Reduced Extinction Ratio Concerns

Re-present slides from Naruto TANAKA, Daisuke UMEDA

IEEE P802.3cc 25GbE SMF PMDs Task Force meeting, New Orleans

BER results

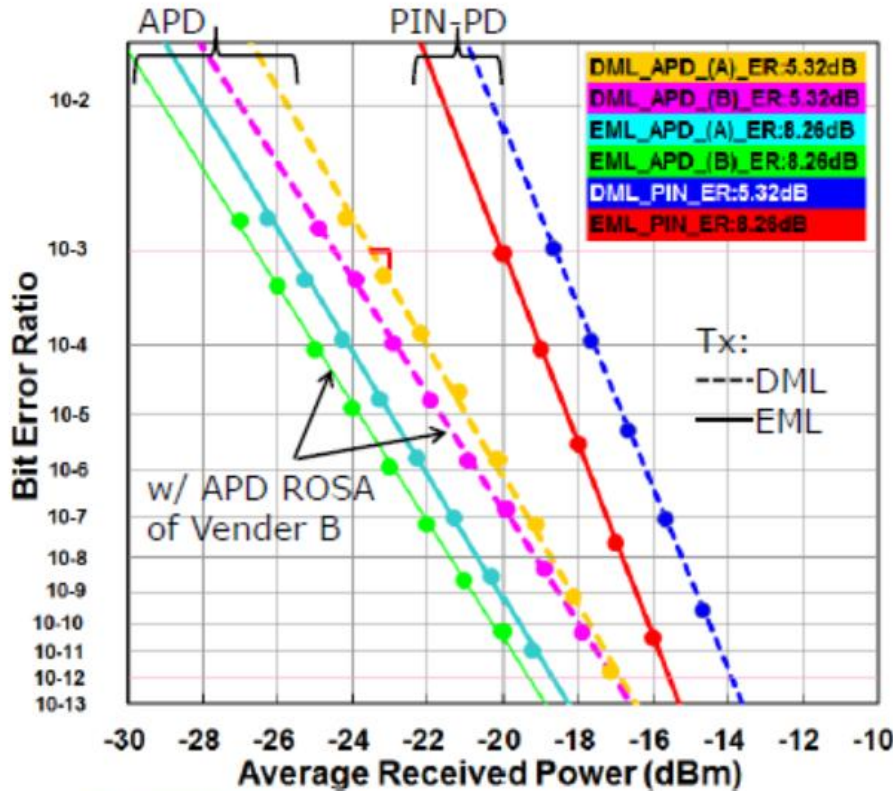
- 0.8dB differences of OMA sensitivities with both APD ROSAs b/w DML and EML
- 5~6dB differences b/w PIN and APD (1dB differences of sensitivities between two venders)

ER dependency of OMA sensitivity

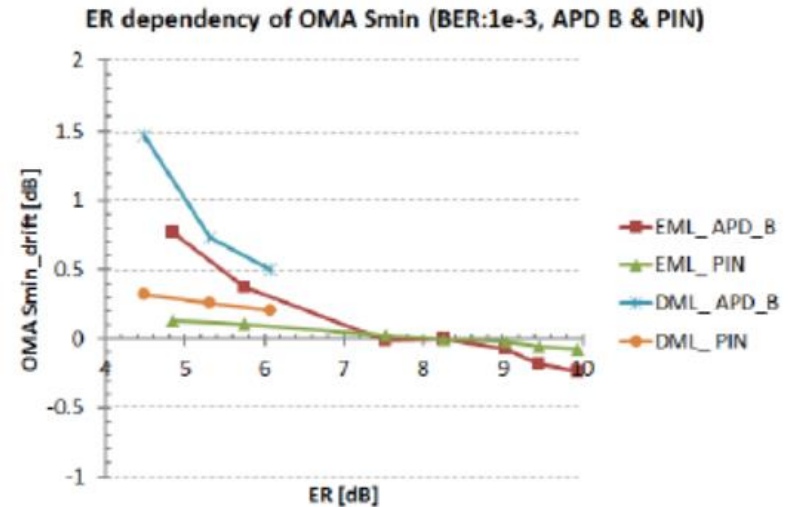
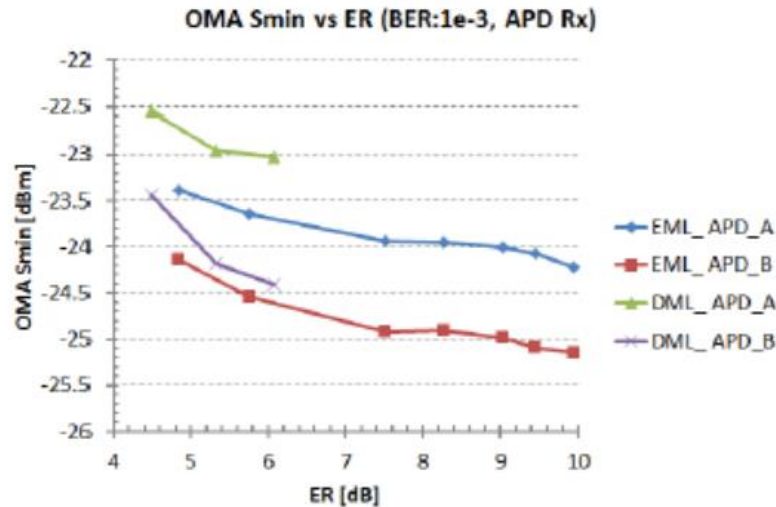
- OMA sensitivities are degraded w/ low ER Tx.
- They are degraded w/ DML Tx more than EML Tx. (Both APD ROSAs have same tendencies.)
- Normalized to results w/ 8dB EML Tx.
- PIN-PD ROSA has no ER dependencies and 0.1~0.2dB difference b/w DML Tx and EML Tx. (This difference of PIN-PD ROSA's results is TP)

→ *Although proposed changes to minimum allowed extinction ratio are small (0.5dB reduction), further degradation of sensitivity for APD-based receivers is a concern.*
